Invitation to Bid No. 24-14

Addendum #2

OLD PAPER MILL ROAD
PARK

ES-101

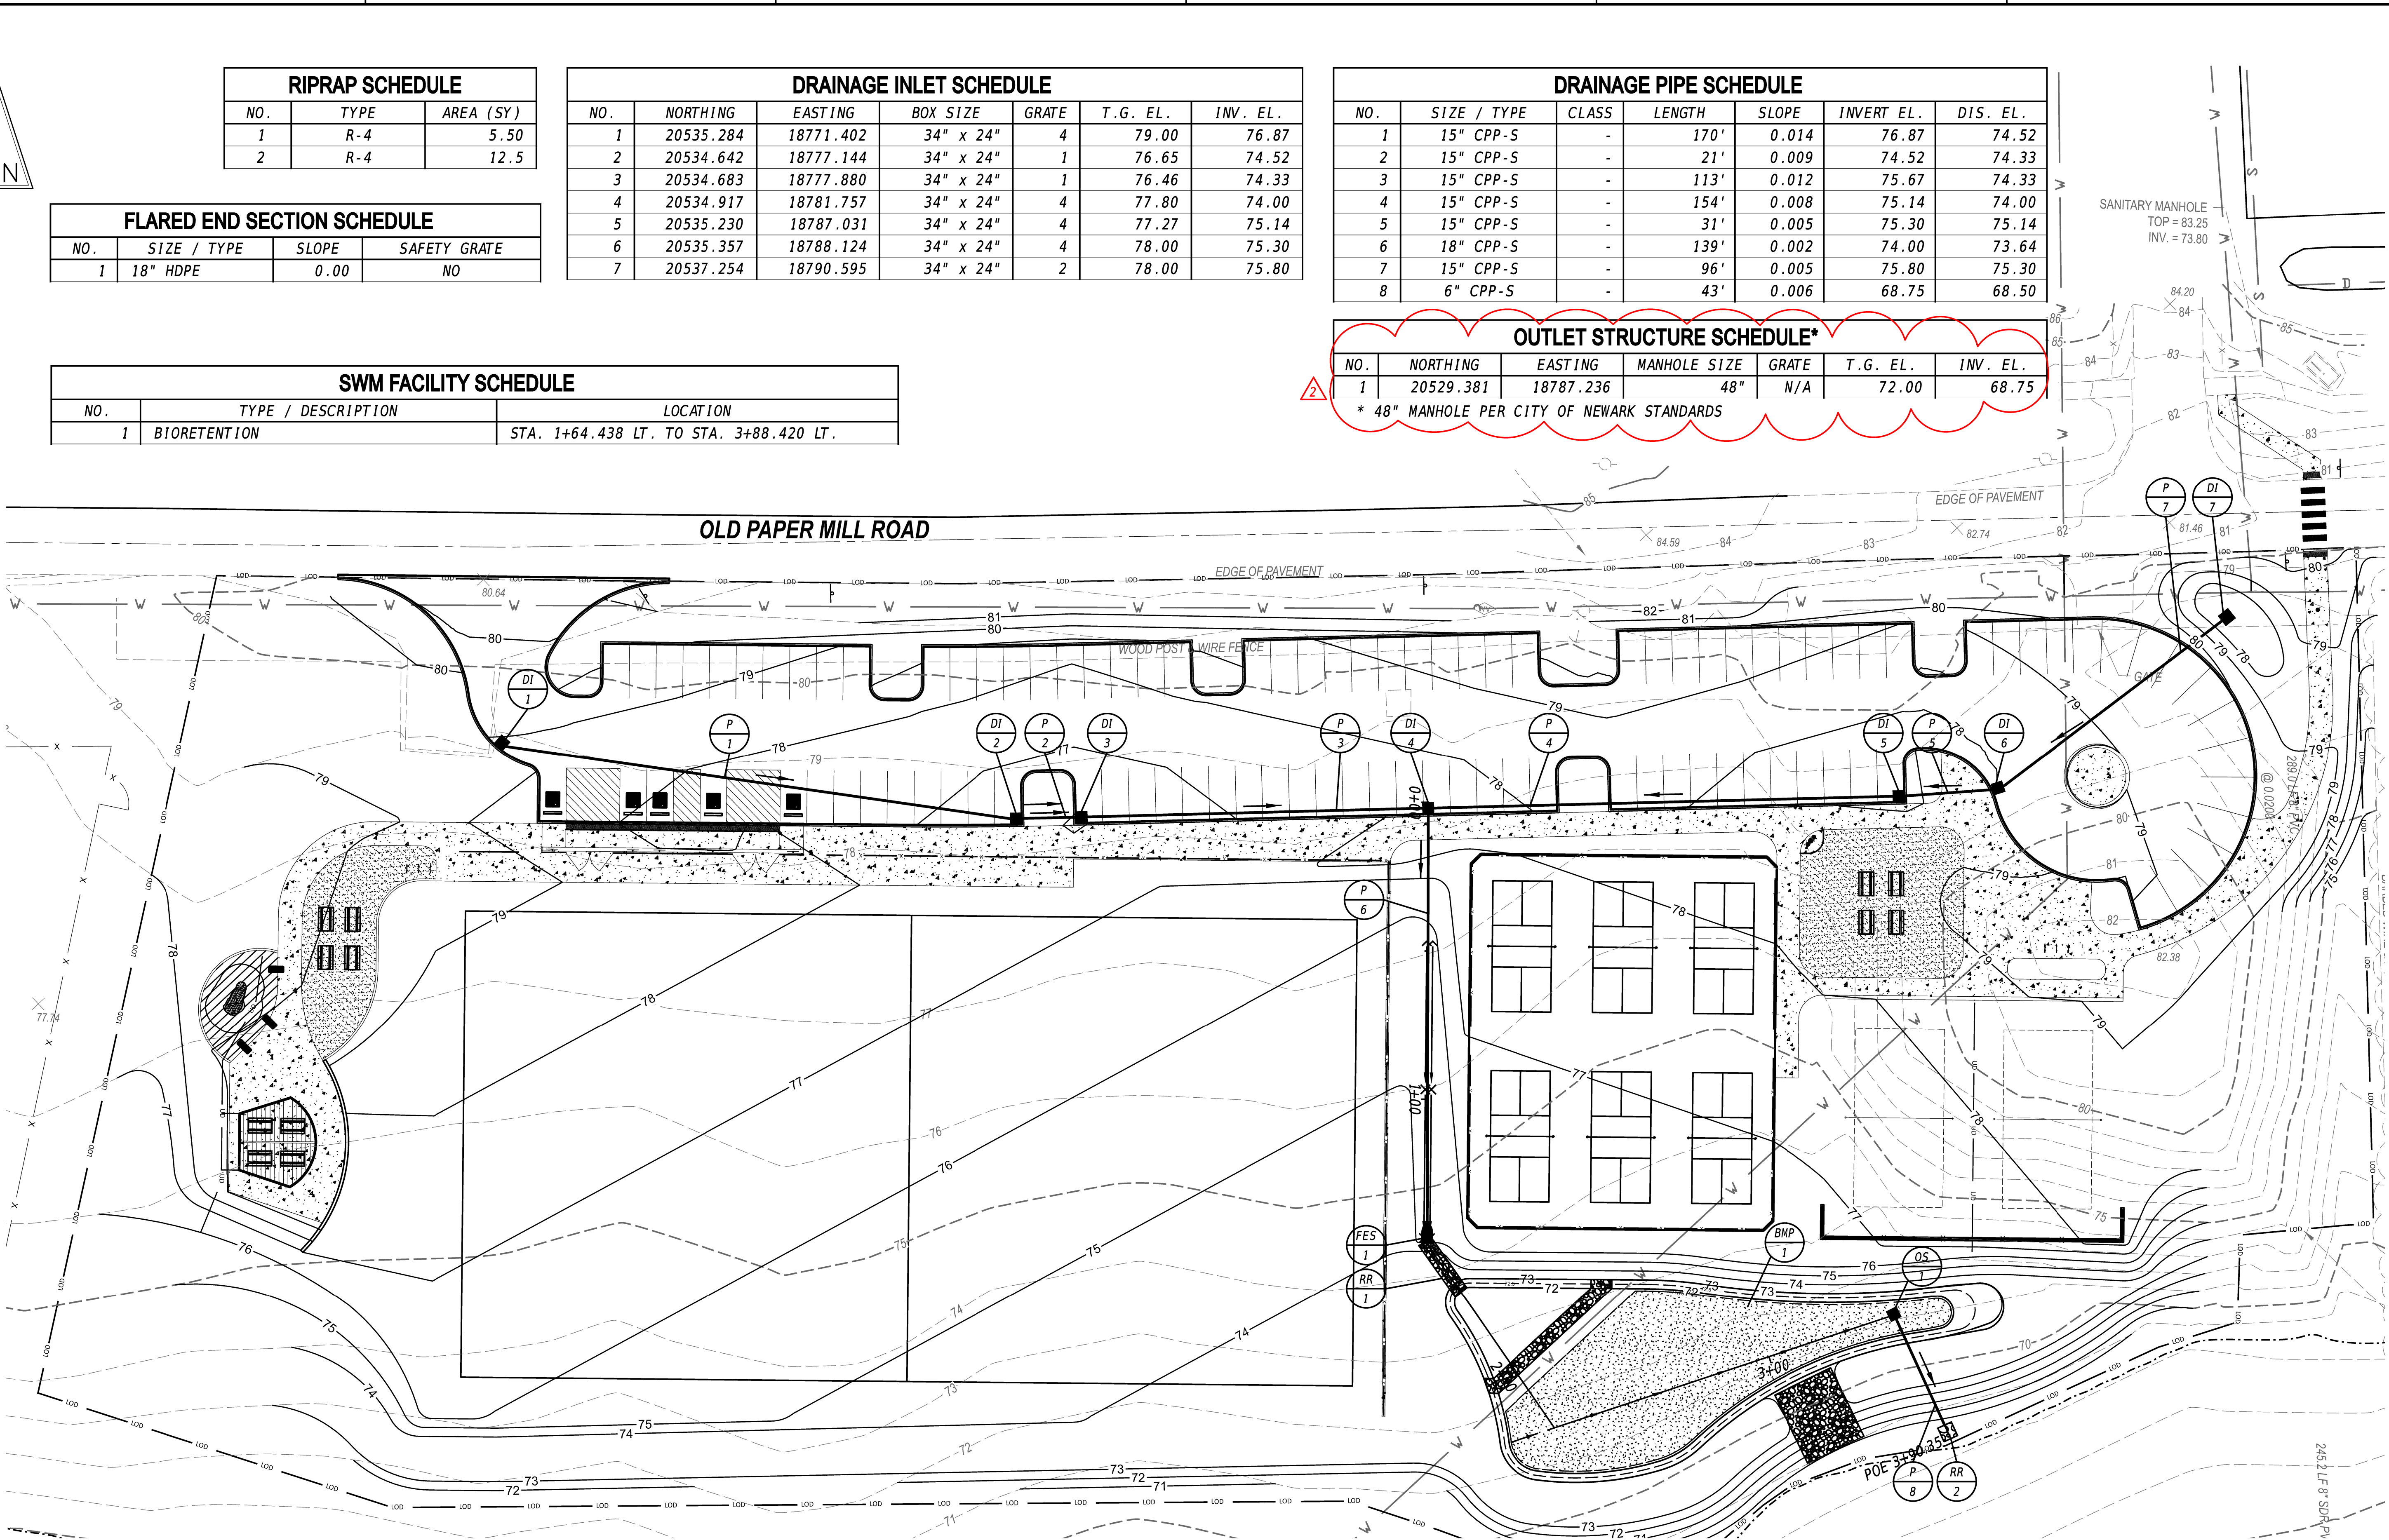
Question 1:	SW-101 - STORMWATER PLAN - All the inlets listed in the schedule are 24"x34" in size. On ES-101 - E&S PLAN inlets 1, 4, and 6 are shown having a single IP-3 inlet protection. Inlets 2, 3, and 5 are shown having a double IP-3 inlet protection. A 24"x34" inlet has a single frame and grate. How many inlet protections should all 24"x34" inlets have?
Response 1:	1 Inlet Protection for each drainage inlet. An updated plan sheet has been provided with this Addendum.
